DEVIATION REQUEST AND DECISION FORM

Project Name :	Hillside at Lorson Ranch
Schedule No.(s) :	5500000370, 5500000371, 5500000405, 5500000281, 5500000282, & 5500000283
Legal Description :	See Attached

A deviation from the standards of or in Section 2.5.2.(C3) of the Engineering Criteria Manual (ECM) is requested.

Pedestrian ramps at "T" intersections.

HILLSIDE AT LORSON RANCH	
 Matrix <i>Excellence by Design</i>	
2435 Research Parkway, Suite 300 Colorado Springs, CO 80920 Contact: Jason Alwine Phone (719) 575-0100 Fax (719) 575-0208	
S:\21.1129.011 Lorson Ranch Area R100 Dwg\105 Exhibits Deviation-2	
DEVIATION 2 EXHIBIT	
01 / 24 / 2022

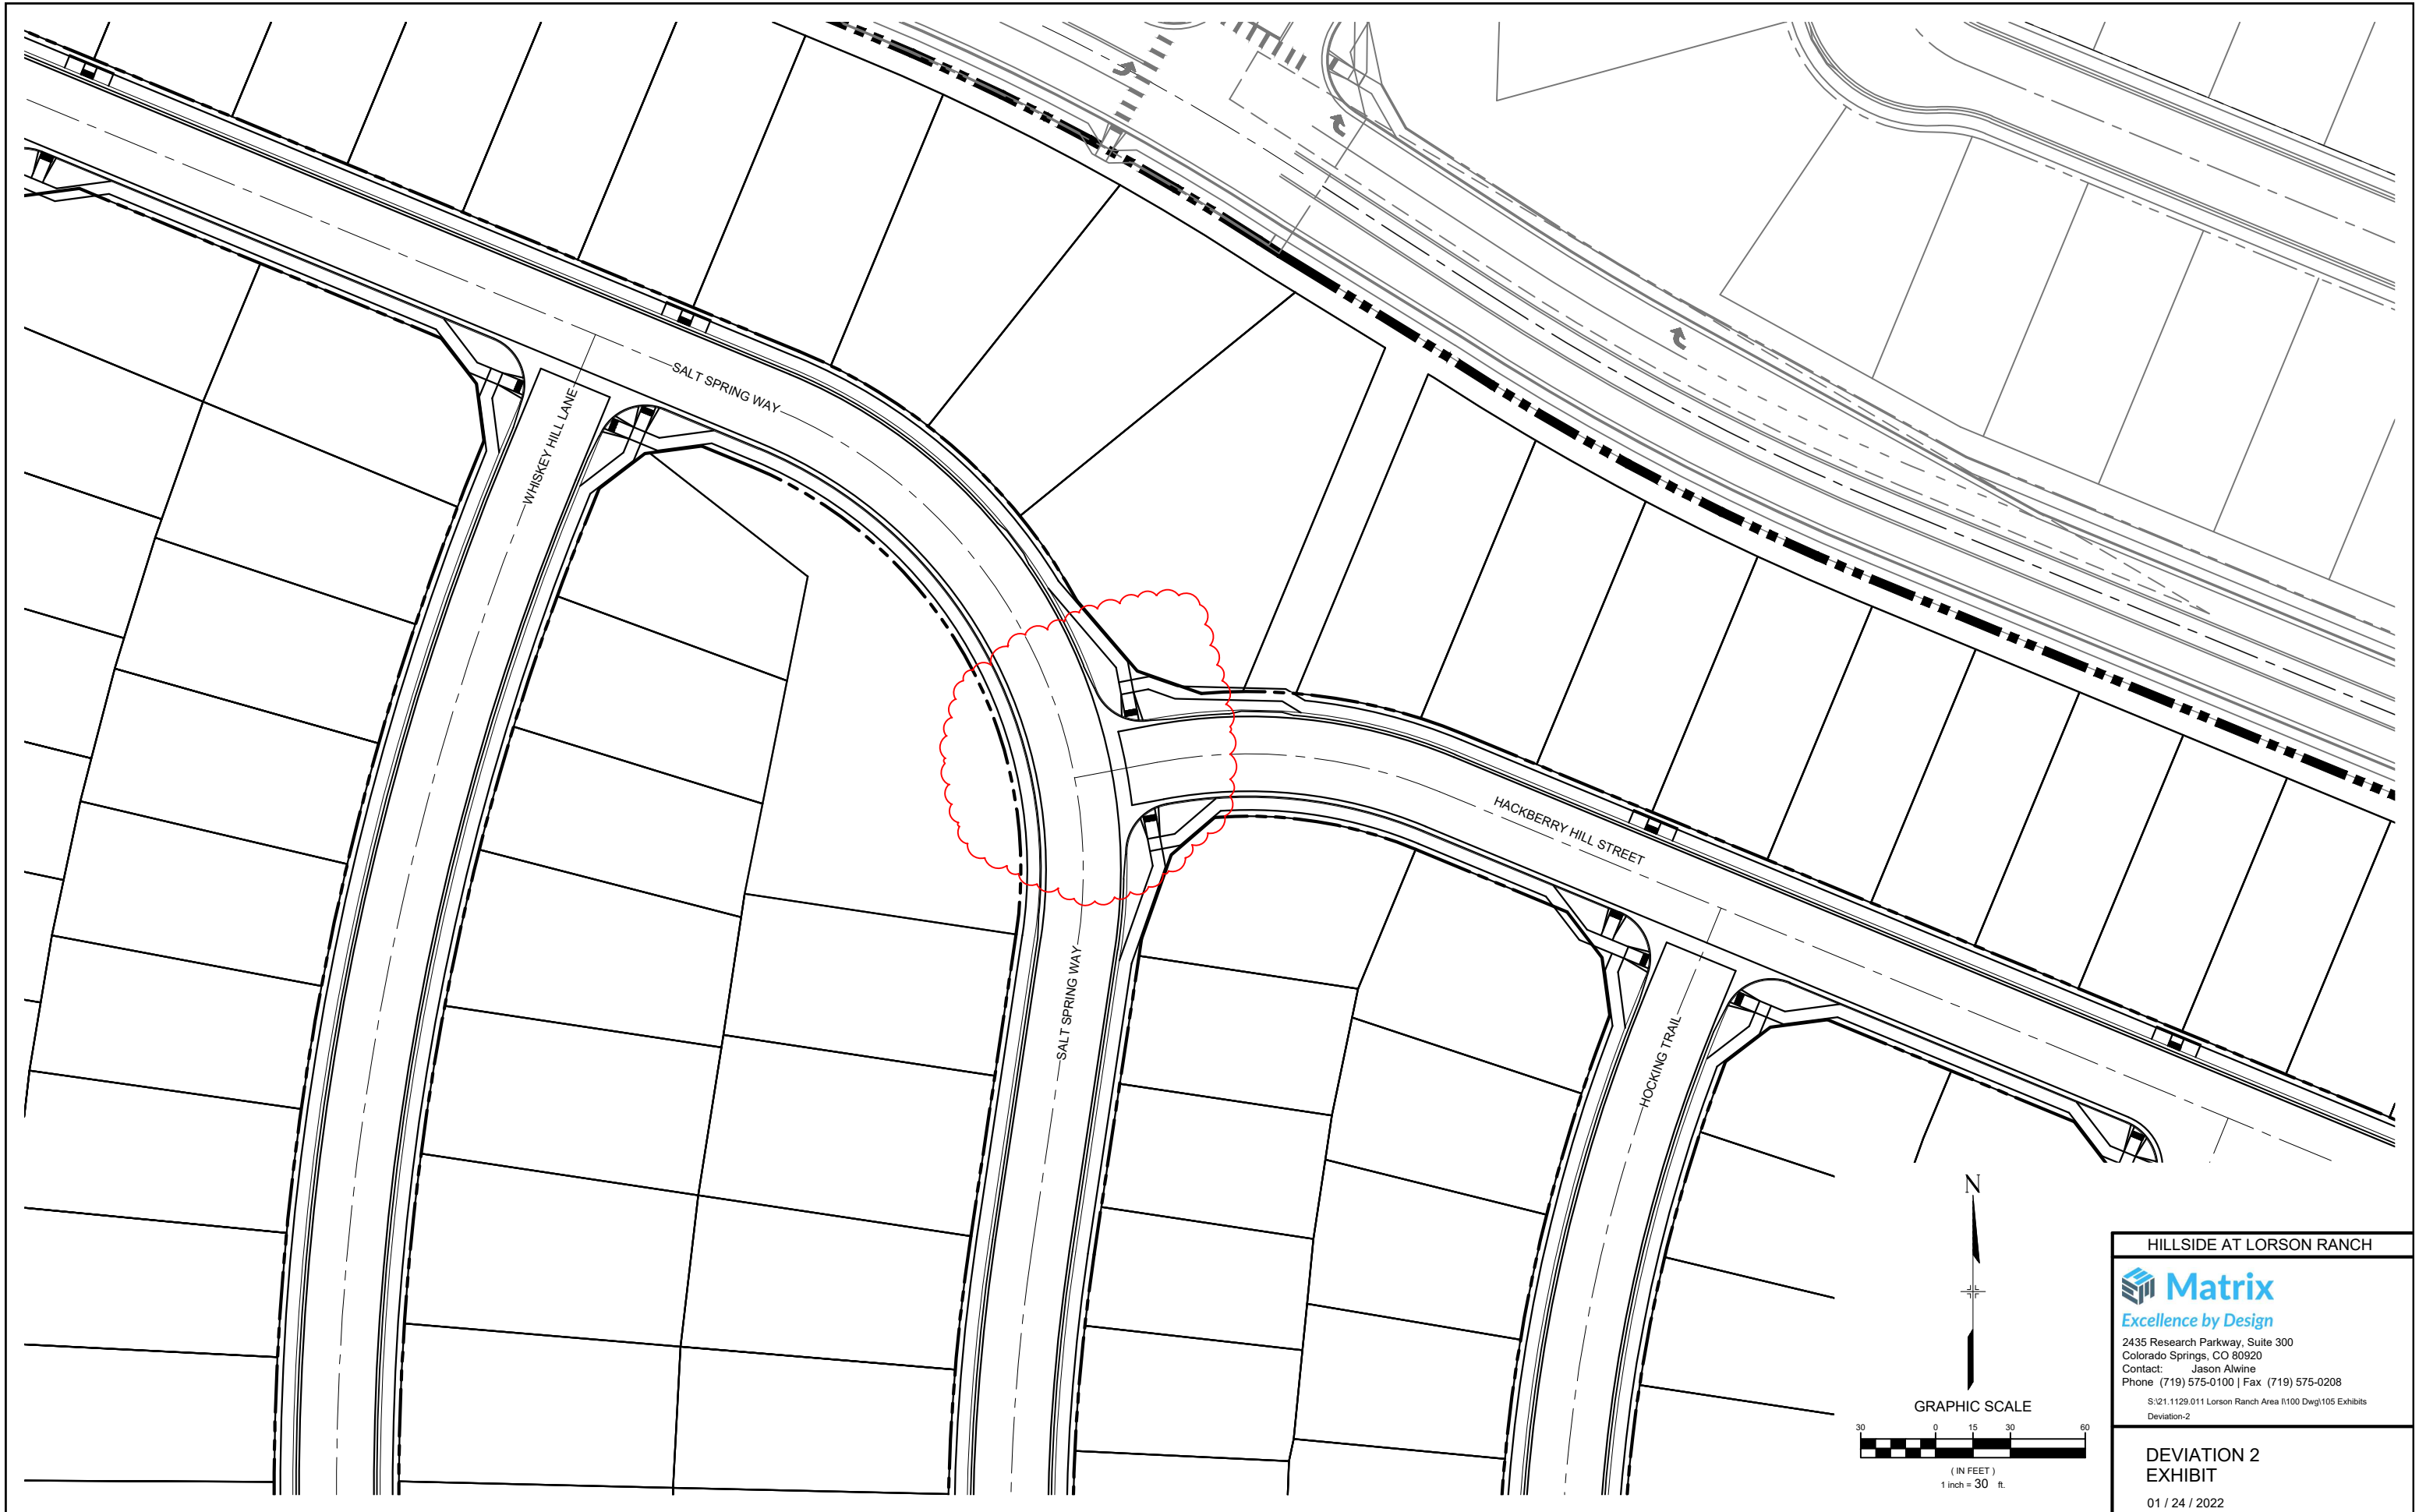
Allow only two pedestrian ramps to be constructed at the T-intersection of Hackberry Hill Street and Salt Spring Way.

The proposed alternative is to construct two pedestrian ramps crossing Hackberry Hill Street and no ramps crossing Salt Spring Way at this T-intersection. The ECM standard is for T-intersections to have a minimum of four curb ramps.

The intersection is in close proximity of other intersections with all the required ramps constructed. Installation of an additional two ramps at this intersection is not feasible as the grading cannot meet ADA requirements along the ADA curb returns. The additional ramps may also be a safety concern as the removed crossing is in the middle of a large curve. The crossing at Salt Spring Way and Whiskey Hill Lane is approximately 225' feet away and provides a much safer intersection for pedestrian movements.

Elimination of two of the four ramps at this intersection will not impede pedestrian movements and will result in safer pedestrian crossing due to grading concerns and the inability to meet ADA slope requirements (where required). The additional ramps may also be a safety concern as the removed crossing is in the middle of a large curve. A pedestrian will be able to cross at alternate locations within approximately 225' of the eliminated ramps.

This request has been determined to have met the criteria for approval. A deviation from Section 2.5.2.(C2) of the ECM is hereby granted based on the justification provided.
